Point Beach Nuclear Plant, Units 1 and 2  
Dockets 50-266 and 50-301  
Renewed License Nos. DPR-24 and DPR-27

Response to Request for Additional Information  
License Amendment Request 247  
Spent Fuel Pool Storage Criticality Control

#### RESPONSE TO REQUEST FOR ADDITIONAL INFORMATION LICENSE AMENDMENT REQUEST 247 SPENT FUEL POOL STORAGE CRITICALITY CONTROL

**Figure 1 - Axial Burnup Profiles for Fuel Assemblies Containing PPSAs**

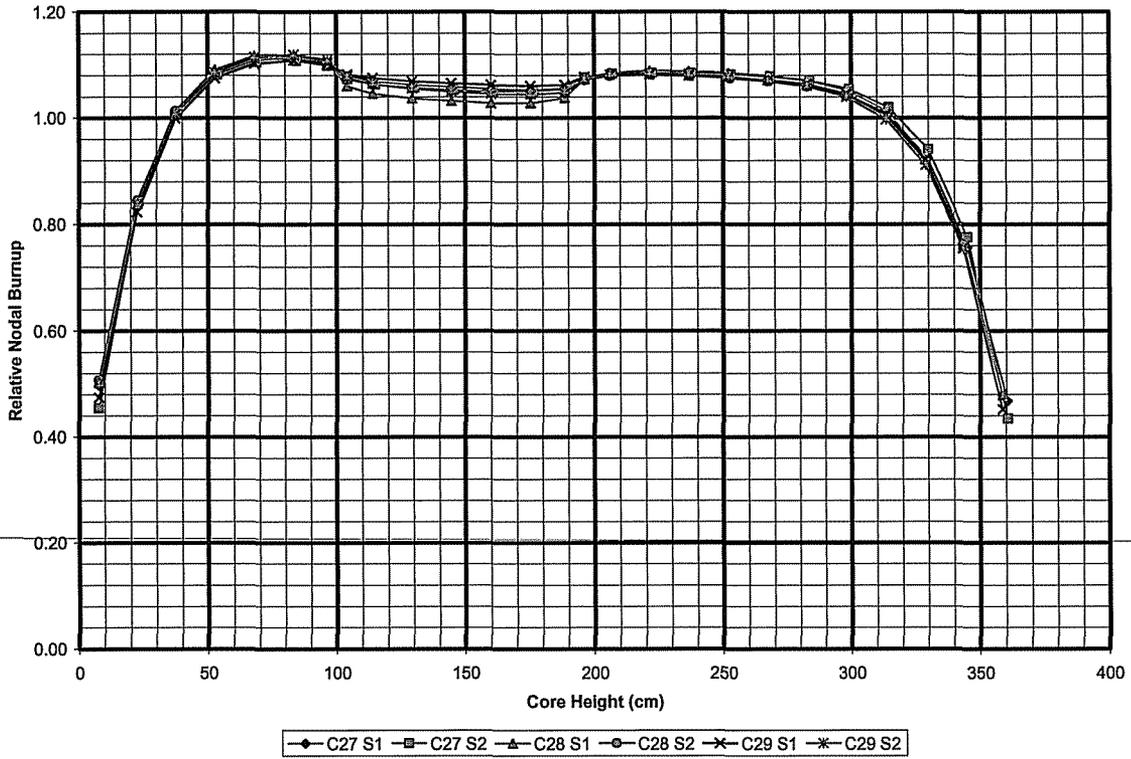
- a) *Please provide a quantitative justification to demonstrate that power suppression assemblies do not result in a more reactive assembly.*

The first step in providing the quantitative justification is a review of burnup profiles for fuel assemblies containing PPSAs for the last several cycles of PBNP Unit 2 operation. The Unit 2 profiles are applicable and representative of both units because the PPSAs have been used with the same strategies in both units. Six unique burnup profiles from assemblies containing PPSAs in Unit 2 Cycles 27 – 29 are presented in Figure 1.

Examination of Unit 2 burnup shapes in the context of PPSAs yields two potentially limiting profiles; Cycle 27 Shape 2 (C27 S2) and Cycle 28 Shape 1 (C28 S1). The C27 S2 profile is selected because it has the lowest relative burnup at the top of the assembly and is expected to have the most limiting, or highest, end effect reactivity of these assemblies. The C28 S1 profile is selected because it exhibits the largest local relative burnup suppression from PPSA use. Both fuel assemblies were discharged after four cycles of operation. The C27 S2 assembly contained a PPSA for its final cycle of operation and was discharged with a burnup of 56,553 MWd/MTU. The C28 S1 assembly contained a PPSA for its last two cycles of operation and was discharged with a burnup of 48,632 MWd/MTU. The PPSA exposure for this assembly bounds others in the population.
